# NISSAN

# PULSAR NX MAXIMA 3002X TRUCK/ PATHFINDER

1988 Models Introduction

# E.C.C.S. SYSTEM DELETION OF VARIABLE RESISTOR

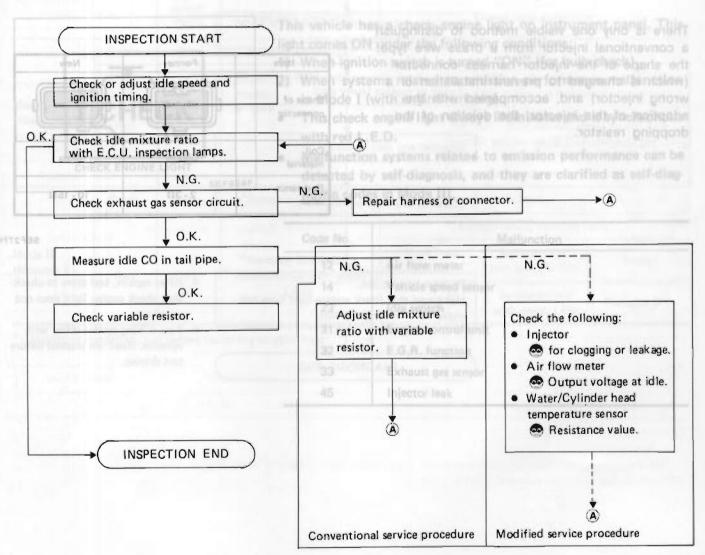
Due to the adoption of a mixture ratio control system with self-learning control, the variable resistor on air flow meter has been deleted. Because of this, there is no need to adjust idle mixture ratio by turning variable resistor. Service procedure for checking idle mixture ratio has been modified as follows:

NOTICE: Broken lines refer to service procedures which have been modified due to elimination of the variable resistor.

### CHECK ENGINE LIGHT (For California only)

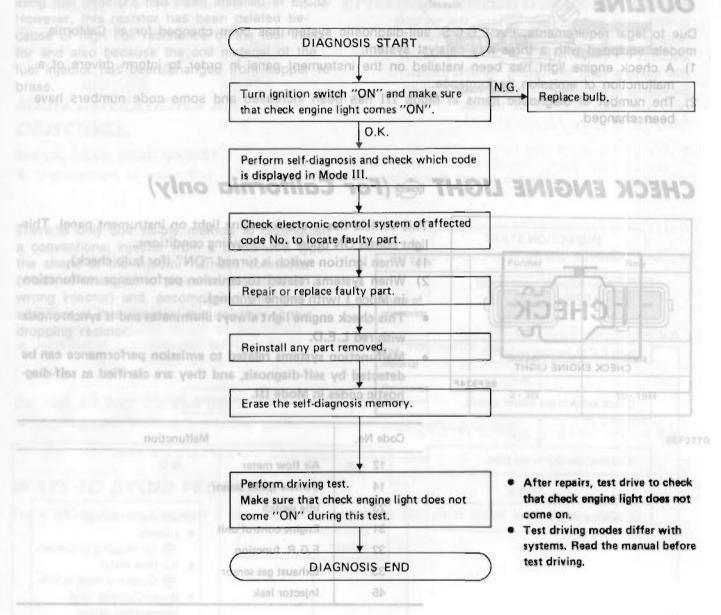
This vehicle has a check engine light on instrument panel. This light comes ON under the following conditions:

- 1) When ignition switch is turned "ON" (for bulb check).
- 2) When systems related to emission performance malfunction in Mode I (with engine running).
- This check engine light always illuminates and is synchronous with red L.E.D.
- Malfunction systems related to emission performance can be detected by self-diagnosis, and they are clarified as self-diagnostic codes in Mode III.

Use the following diagnostic flowchart to check and repair a malfunctioning system when the check engine light is ON at the time of vehicle delivery for service.

# EXHAUST GAS TEMPERATURE SENSOR

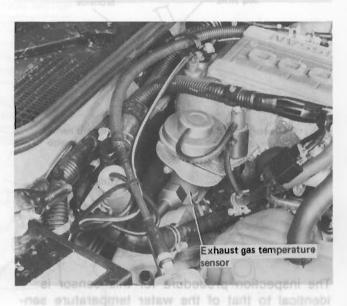
The exhaust gas temperature sensor has been newly installed on exhaust gas passage gallery. This sensor checks whether E.G.R. system is operating normally. The temperature sensing unit uses a thermistor which is sensitive to the change in exhaust gas temperature. Electric resistance of the thermistor decreases in response to a temperature rise.

Operating temperature; -30 to 450°C (-22 to 842°F)

Temperature "C ("F)	0 (32)	50 (122)	100 (212)	150 (302)	200 (392)
Resistance	8,790	635	85.3	17.8	5.09
kΩ	±879	±63.5	±8.53	+1.78	±0.51

- Electric resistance should change when the sensor is submerged in heated water.
- 2) Electric resistance at 100°C (212°F) should be

85.3  $\pm$  8.53k  $\Omega$

### LOCATION OF COMPONENTS

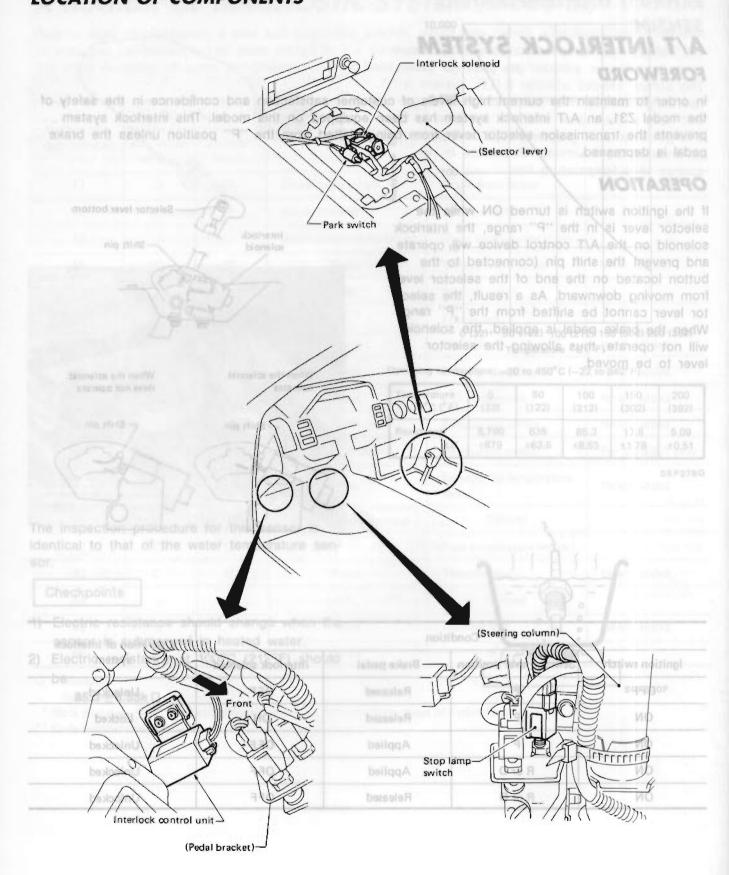
In order to maintain the current high levels of customer satisfaction and confidence in the safety of the model Z31, an A/T interlock system has been equipped on this model. This interlock system prevents the transmission selector lever from being shifted from the "P" position unless the brake pedal is depressed.

If the ignition switch is turned ON while the selector lever is in the "P" range, the interlock solenoid on the A/T control device will operate and prevent the shift pin (connected to the button located on the end of the selector lever) from moving downward. As a result, the selector lever cannot be shifted from the "P" range. When the brake pedal is applied, the solenoid will not operate, thus allowing the selector lever to be moved.
